TS 940 Mods

Expanded xmit for Kenwood TS-940S

TS-940S AGC circuit improvements

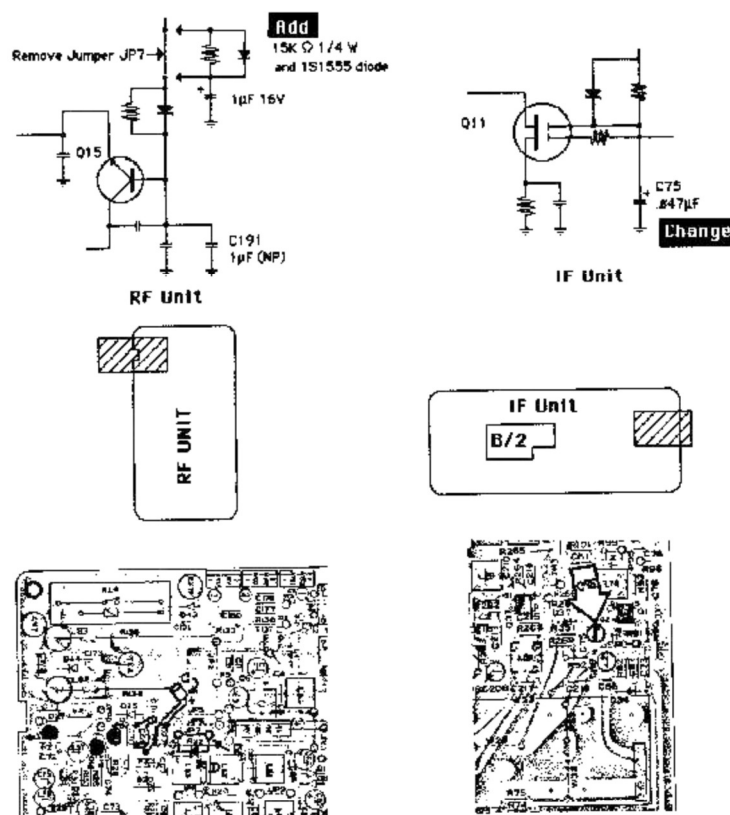
The following changes will improve the adjacent rejection of the TS-940S when a relatively strong nearby signal is present (s-4 or above).

1. Remove jumper wire JP7 and replace it with the parallel combination of the 15 Kohm resistor and the 1S1555 diode. Pay close attention to polarity.
2. Add the 1 µF capacitor as shown in the diagram.

Change capacitor C75 from a 1 µF 50V capacitor to a .047 µF 50V capacitor.

TS-940S Factory Assembly Mistakes

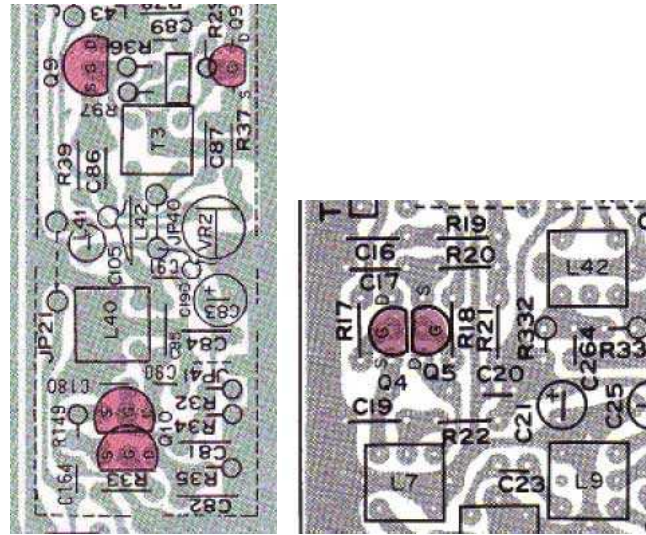
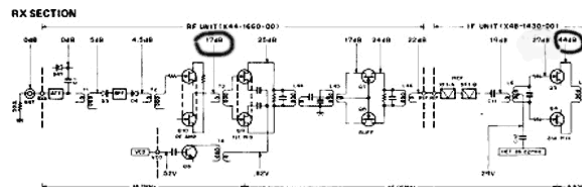
See the FETs Q10 (RF Preamp Preamp 2SK125, N-FET, 25V, 0.1A, 0.3W) and Q4 Q5 (2nd balanced mixer, also 2SK125). The picture above was scanned from the TS-940S Service Manual, Revised Edition. In these pictures the FETs are in the wrong position.

See the Level Diagram in the Service Manual. With the FETs on the right position, we would have 12.5 dB (17 - 4.5) gain in the RF Preamp, and 17 dB (44 - 27) in the 2nd balanced mixer at the indicated points in the picture above. It would be interesting to measure these gains before the correction. With this measurement we would have an idea about the sensitivity losses due to the two errors.

This picture shows the FET in the correct position.

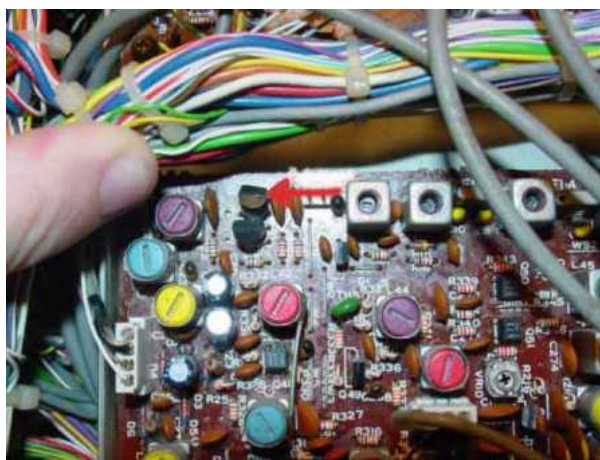
I got back to the Service Manual, and following the circuit diagram, checking the PC boards, I found a second mistake: in the 2nd balanced mixer, in the IF unit, another inverted FET (Q4), harming the mixing/conversion, the gain, and the AGC performance.

TS-940S MRF-485 Driver Transistor News

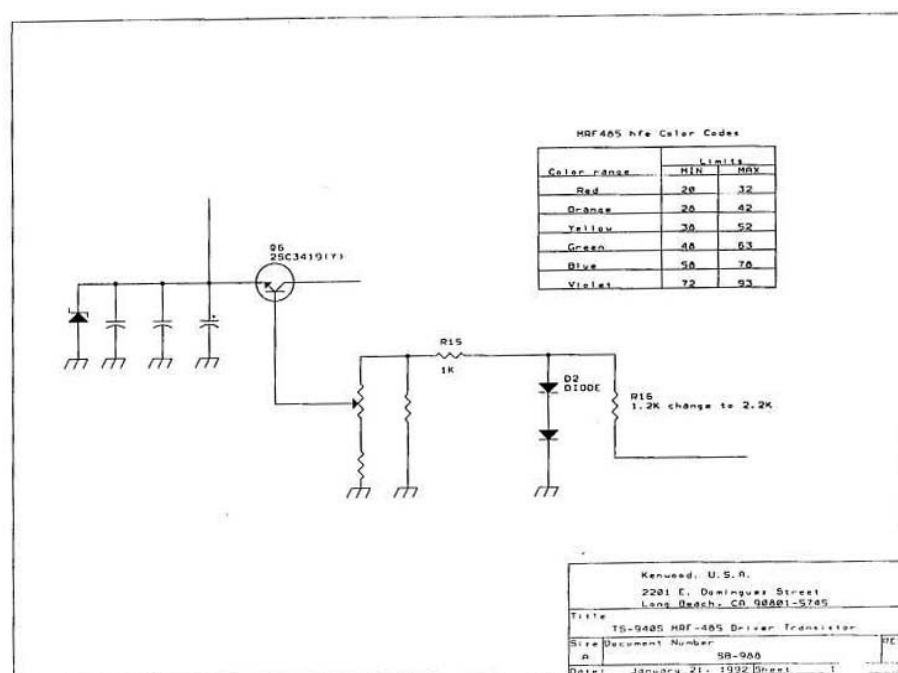
Use of Red, Orange, or Yellow hfe color rankings is recommend. These lower gain transistors work just fine and do not suffer from the circuit instability problem. If you are only able to obtain the high gain transistors you will need to modify the varistor/temperature compensation circuit on the final unit (X45-1400-00) by changing R16 from 1.2 Kohm to 2.2 Kohm.

During its production the TS-940S used two different varistor values. The original part was an STV3H(O). It was changed in mid-production to an SV03YS. R15 was changed from an 820 ohm resistor to a 1 Kohm resistor at the same time. Therefore the countermeasure differs depending upon the serial number of the radio.

TS-940S VCO carrier to noise ratio improvement

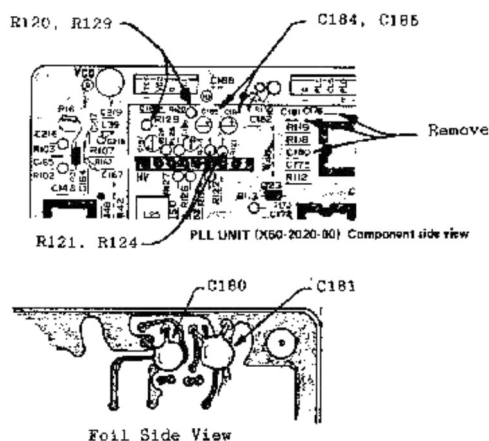
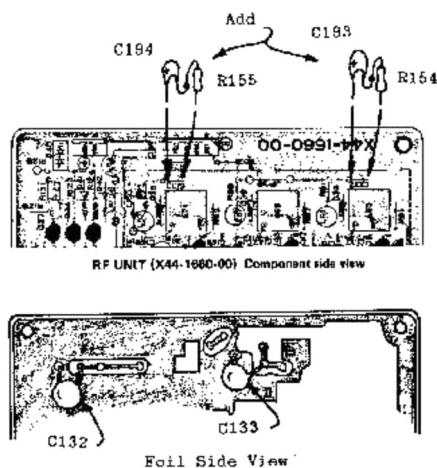
On the PLL unit (X50-2020-00) remove capacitor C176, C180, and C181. Change resistor R120 and R129 from 470 ohms to 3.3 Kohm. Change resistor R121 and R124 from 1 Kohm to 680 ohms. Change capacitors C184 and C185 from .22 μ F to .33 μ F 35V tantalum capacitors. Install C180 and C181 in the positions shown in the accompanying diagrams. The use of new capacitors is recommended to improve reliability, don't try to reuse the old capacitors! Capacitors C181 and C180 should be attached to the foil side of the PLL unit.

On the RF unit (X44-1660-00) install the series RC circuit composed of R154 and C193, and R155 and C194, as shown in the accompanying diagrams. As the diagrams illustrate it is easiest to move C132 and C193 to the foil side of the board and install the series RC circuit on the component side.

TS-940S PLL unlock

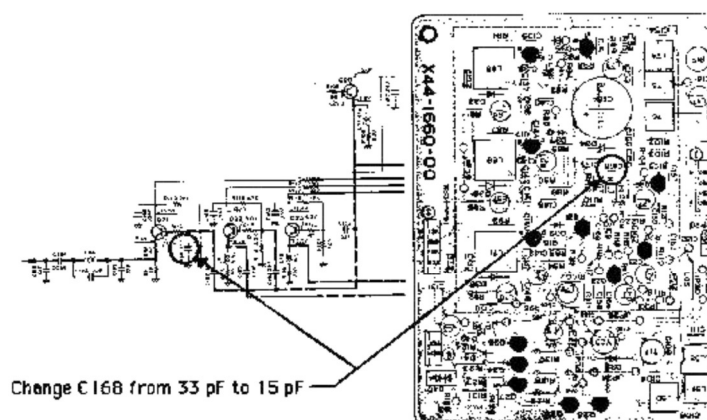
Reports of a PLL unlock on the lower frequencies may be due to low VCO levels. The following change will increase the VCO level and should prevent reoccurrence of this symptom.

1. On the RF unit (X44-1660-00) change C168 from a 33 pF capacitor to a 15 pF 50V capacitor.
2. Readjust the VCO BPF (RF unit L74-76) according to the instructions contained in the TS-940 Service manual.

ALC time constant

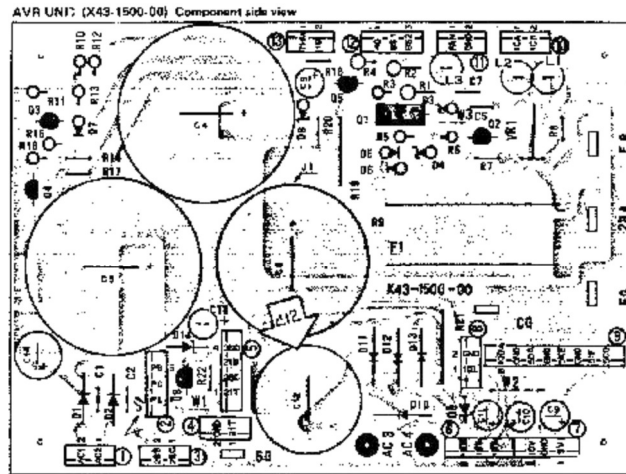
1. This Mod will change the TS-940 time constant from approximately 1 second to .022 second. This means that the ALC will no longer impose its own characteristics on your audio response; the ALC will now follow your own syllabic rate and emphasis. Usually the average output will increase, which will drive a linear amplifier harder (or at least those meters will swing higher!!). Use caution in this mod and have another Ham-friend check around your TX frequency for splattering while you are QRV.

2. The TS-940 has a 10uF cap (C31) and 100K resistor (R104) which make up the time constant for the ALC. This tends to reduce the output power for the duration of the ALC time constant (or till the circuit charges up again). Then it starts all over again on the next word.

3. This procedure allows modification to the control PCB (X53-1420-11) in the TS-940 WITHOUT having to remove the board. Remove the bottom cover and locate the control PCB. Locate R137 and R104. These are located in the upper right hand corner as the rig faces you upside down (near VR-3). A service manual is helpful for locating parts!!!
Using an Exacto knife, VERY CAREFULLY scrape off some insulation from the top of these two resistors. Now tack-solder a 1/8 watt 2.2k ohm resistor from the top of one of these resistors to the top of the other. The time constant is now changed. Reassemble and enjoy a superb rig.
